Figure 2.1m
Infrastructure Design Review
- Turbine 15

Bhlaraidh Wind Farm Extension
S36C Varied Development

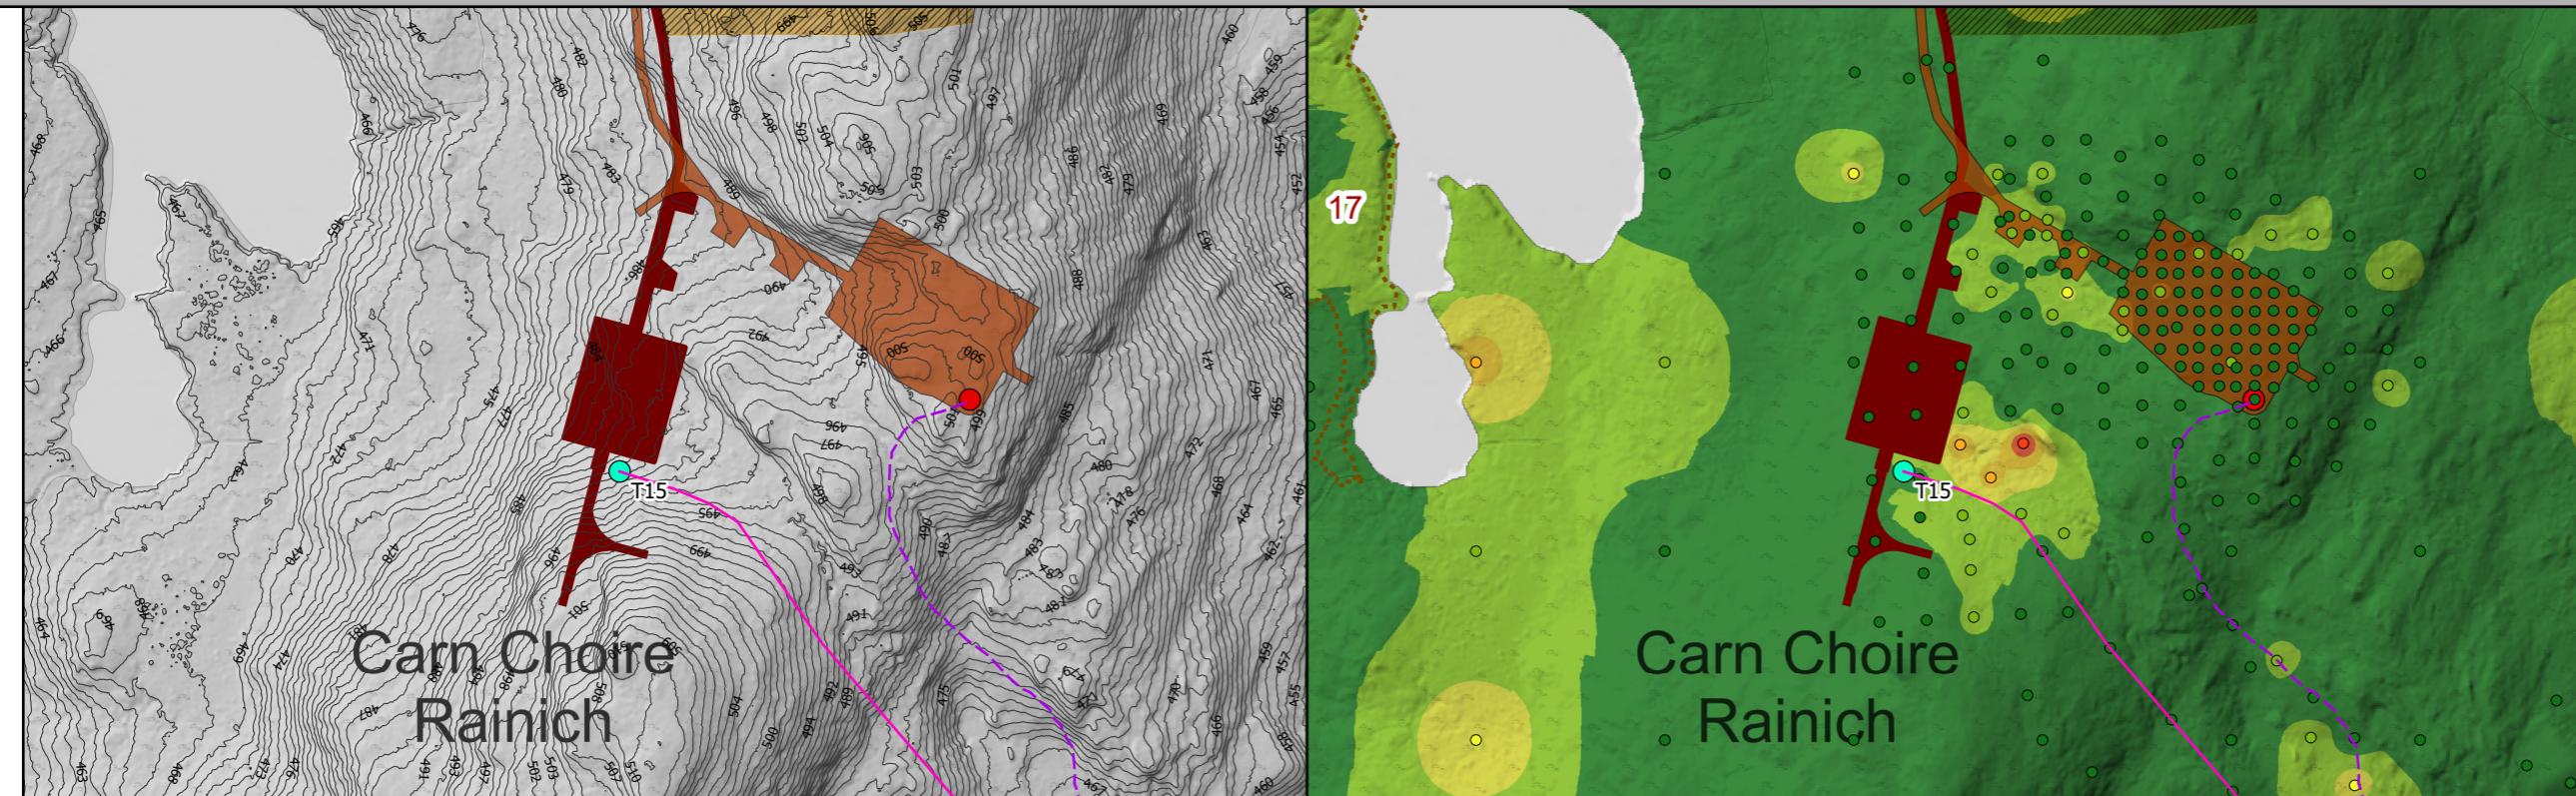
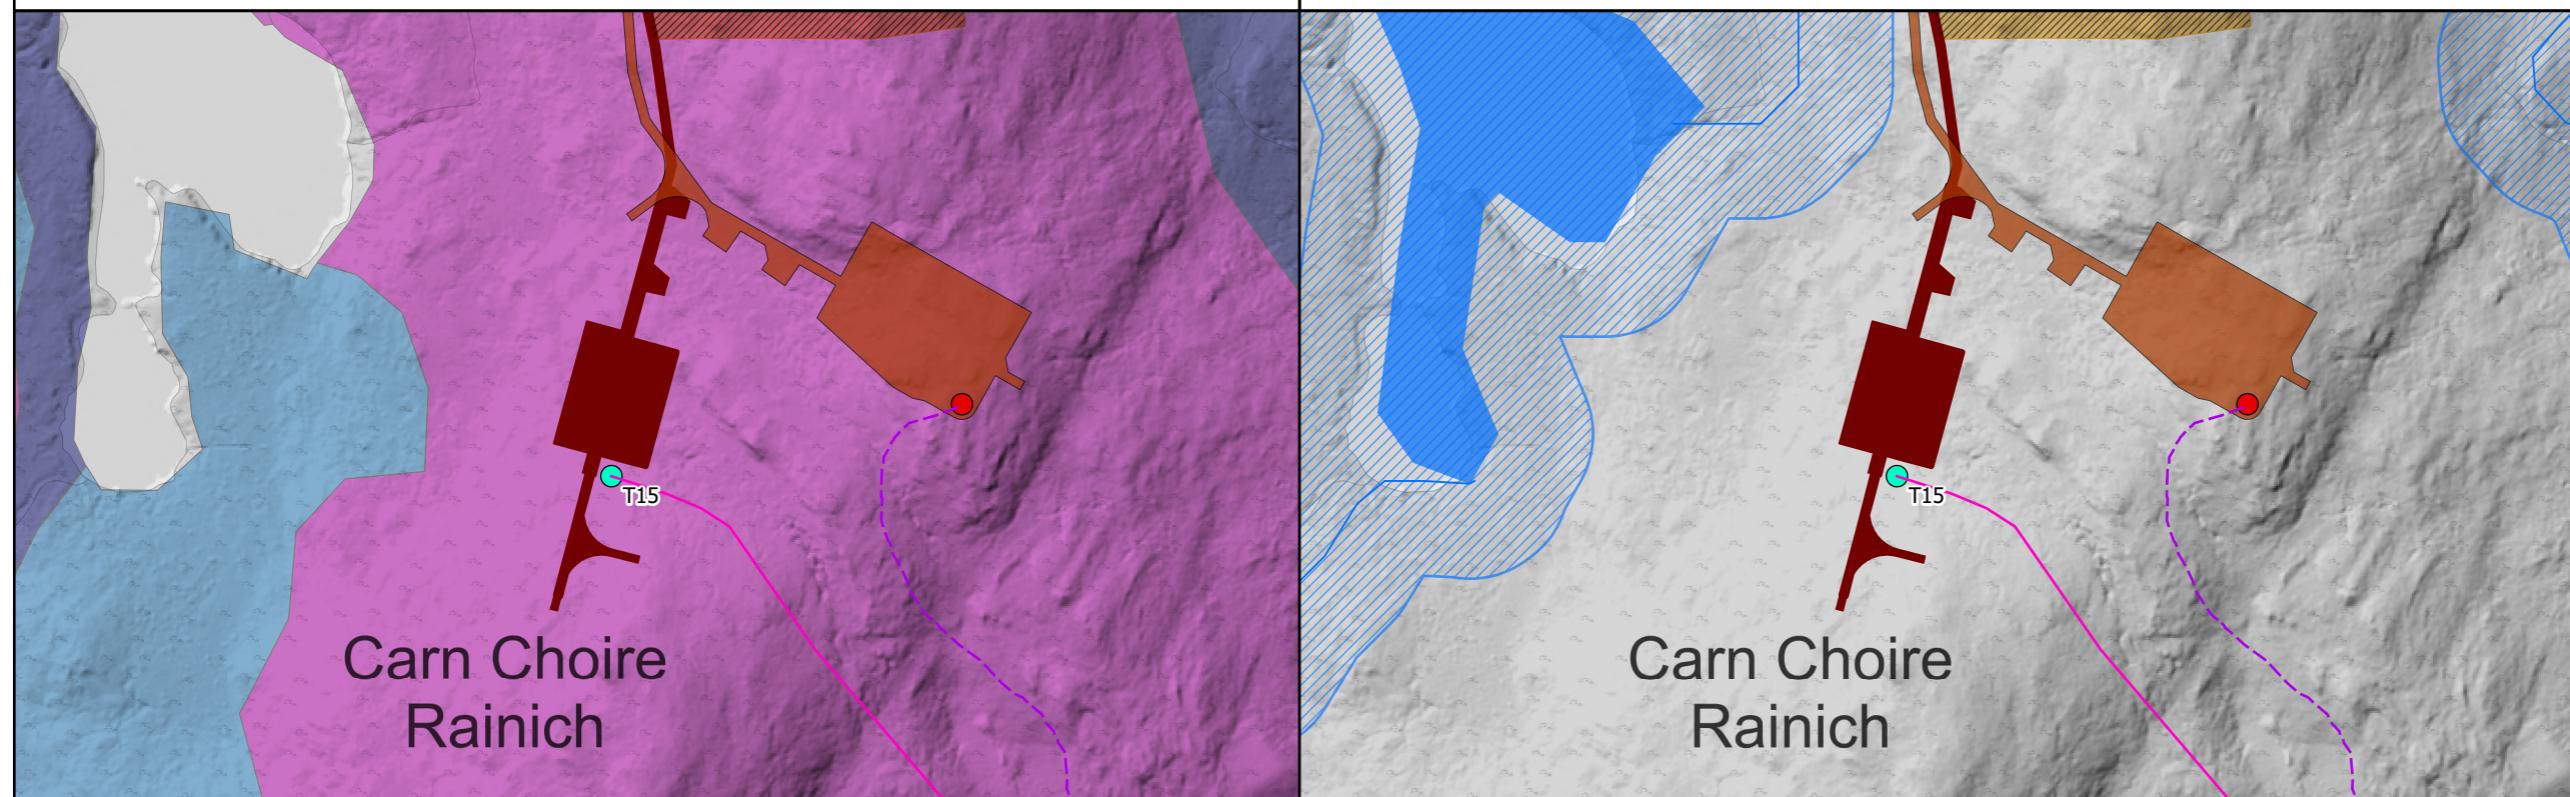
T15: Reason for Moving: The move is necessary to increase turbine spacing to more than three times the rotor diameter from its closest neighbouring turbine. This adjustment was needed because T10 had to be moved east due to safety concerns regarding the toppling distance to the substation platform. Increasing the spacing reduces the impact of wake-related losses, which occur when turbines are too close to each other.

Engineering: The alignment of the access track has been primarily maintained, with only the hardstand / turbine being substantially relocated to avoid a local valley with deeper peat in the area East of the Consented position

Geology Impacts: Both the consented and proposed infrastructure locations are situated in areas of shallow and medium depth peat. If the consented turbine location was to be maintained with the required hardstanding, areas of deep peat would be impacted. The cross country cable cross route still to be determined and may need to exceed a 50m micrositing zone shown as noted in the current planning documentation.

Ecology Impacts: As with the current consented infrastructure, the new layout is entirely within Wet Heath (M15c).

Hydrology Impacts: The proposed location is outside the 50m water buffers. Although not shown as water courses on the map, it was noticed that there are channels within the landscape that were likely to carry water, these areas have been avoided which has resulted in the turbine location being further east than strictly necessary to satisfy other design drivers.
